Subject: AP1000 COL Standard Technical Report Submittal of APP-GW-GLN-143, Revision 0 (TR-143)

**Title: Evaluation of the Effect of Shield Building Changes on
Containment Response and Safety Analyses**

WESTINGHOUSE ELECTRIC COMPANY
AP1000 Licensing Design Change Document

Figure 3-1: AP1000 PCS Air Flow Path Inlet Configuration – Revised Shield Building Design

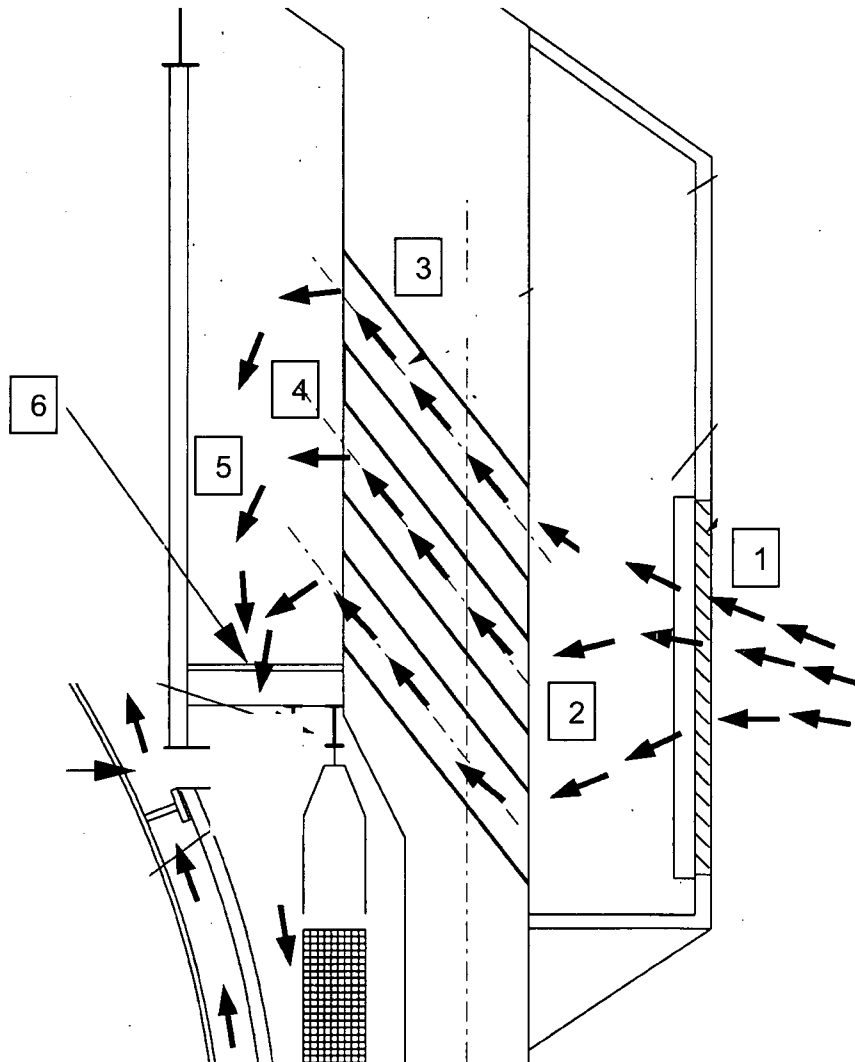
The air inlet structure for the AP1000 revised shield building design is shown in Figure 3-1. Air enters from the environment into a common plenum through 29 distinct openings, 9.5 ft high by 12 ft wide. Each opening has fixed louvers and screens to protect against weather and wildlife. The net flow area through the openings is 1253 ft². The common plenum is located behind these openings, but outside the shield building concrete wall. This plenum extends completely around the circumference and encloses a walkway for inspection of the louvers and screens. The walkway also provides access for inspection of the PCS air inlets; a series of 384 ducts that admit air from the plenum outside the shield building to a common plenum inside the shield building.

The air inlets through the shield building wall consist of 384 angled ducts with rounded entrances. The air enters through these ducts into a common plenum inside the shield building where it turns approximately 135° and enters the downcomer annulus through a restriction. Thus, the total resistance of the inlet assembly is made up of six parts, labeled 1-6 in Figure 3-1. These are:

Figure 4-1: Comparison Pressure Plot for DBA Cold Leg LOCA

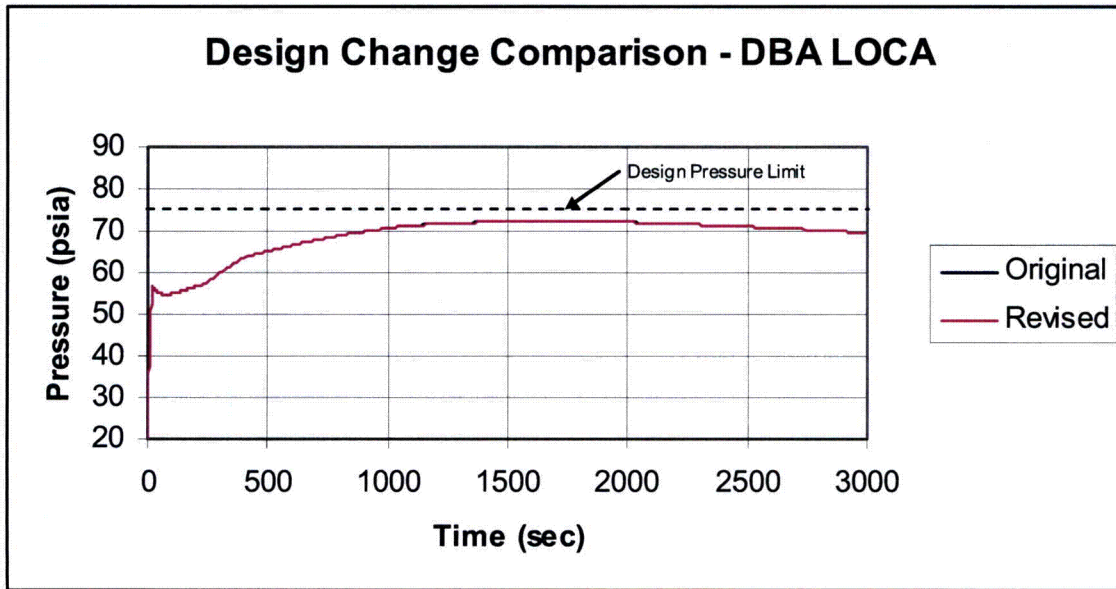
For this case, the pressure increases very rapidly due to the initial blowdown event. As the internal passive heat sinks (including the containment shell) begin to condense steam, the pressure levels off. As the RCS and steam generator sensible heat is released to containment, the pressure increases, eventually reaching a peak at about 1800 seconds after the event initiation. The PCS water evaporation effectively cools the containment shell and the pressure slowly decreases. The containment pressure response for both the previous design and the revised design are shown in Figure 4-1. The difference between the two cases cannot be differentiated on the plot.

These results show that there is a negligible impact on the peak pressure for DBA resulting from the revised shield building design. There is a small reduction in air flow through the PCS due to the more restrictive air flow path, but the evaporative heat transfer which makes up the majority of the heat removal from the containment shell is not affected by this reduction. Since the overall heat removal for both designs is essentially the same, the peak pressure is also the same. Thus, the revised shield building design has no adverse impact on the ability of the PCS to mitigate a design basis event.

Figure 4-2: Comparison Plot for BDBA Loss of Offsite Power

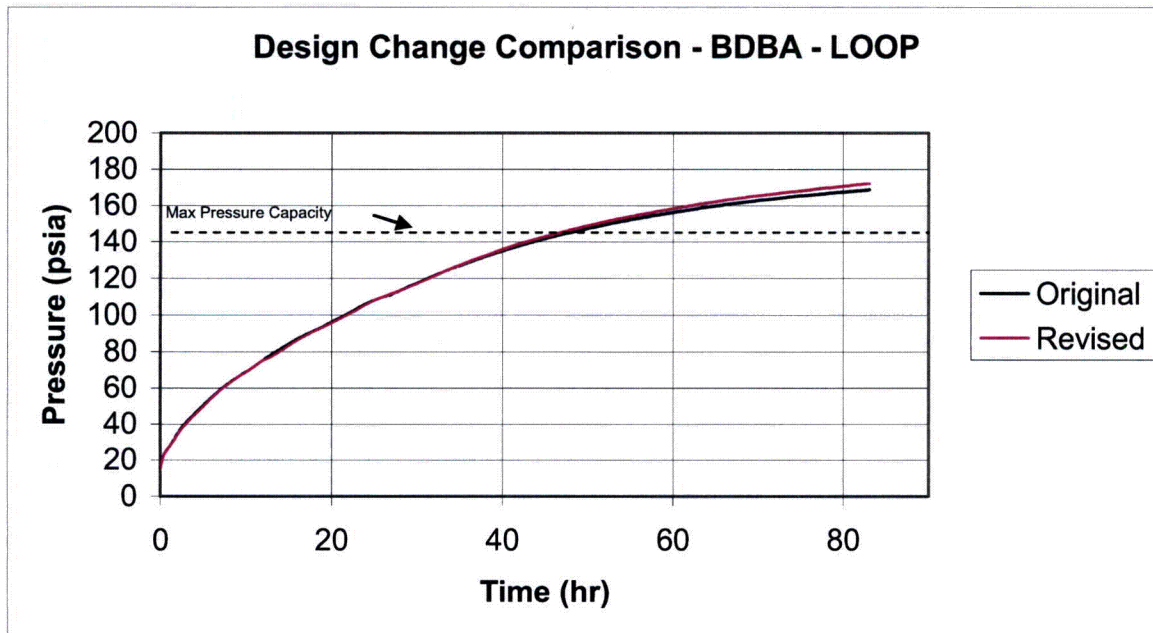
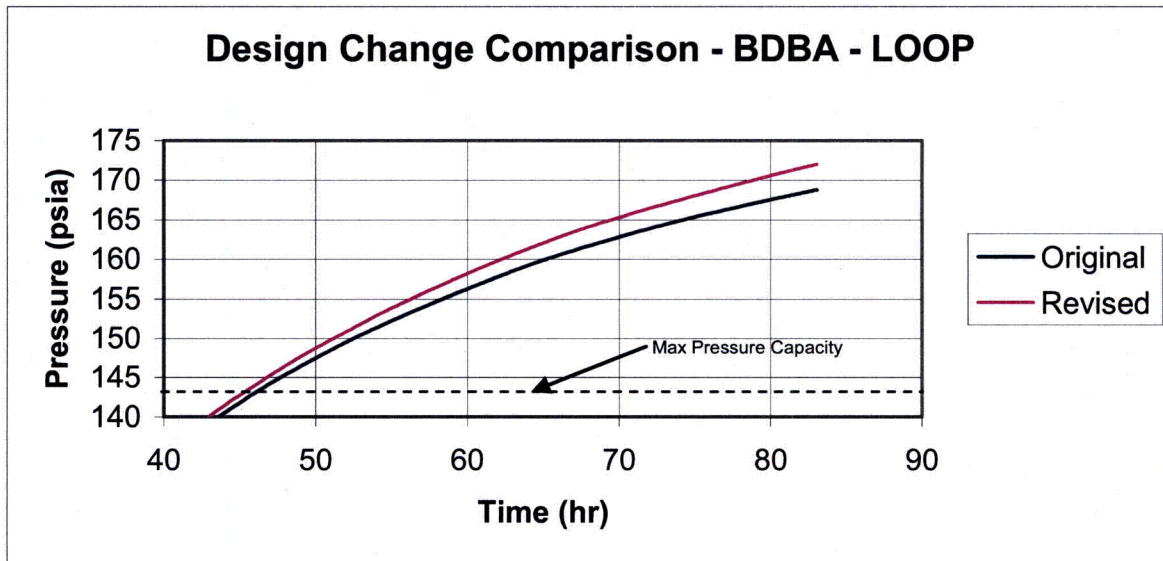
The results of the BDBE case are shown in Figures 4-2 and 4-3. For this case, the increase in pressure occurs very slowly and no significant difference between the original and revised shield building designs becomes apparent until a long time after the event initiation. Figure 4-2 shows that both cases reach the maximum containment capability limit of 143.7 psia at approximately 45 hours. This allows considerable time for operators to either repair the PCS water supply, or to provide alternative water sources. Figure 4-3 shows the difference between the containment responses for the two designs on an expanded scale. The increased flow resistance of the revised design eventually results in a containment pressure that is approximately 5 psi higher 83 hours after the initiating event.

FIG. 12
AIR FLOW AREA 5 (THRU BEAMS)
03.05.07

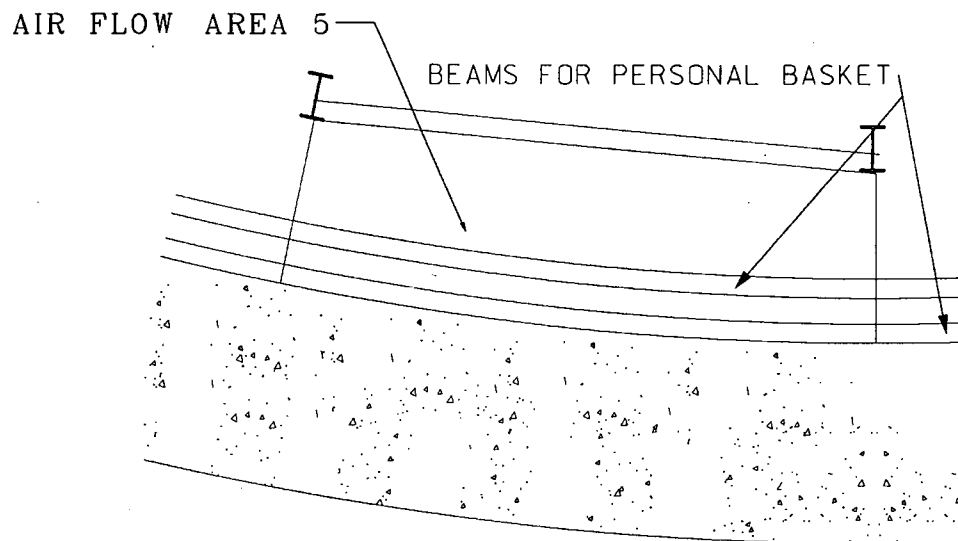
FREE FLOW AREA SF = 51.7 SQ FT

TOTAL FREE FLOW AREA = $29.5 \times 51.7 \times 0.78 = 1190$ SQ FT
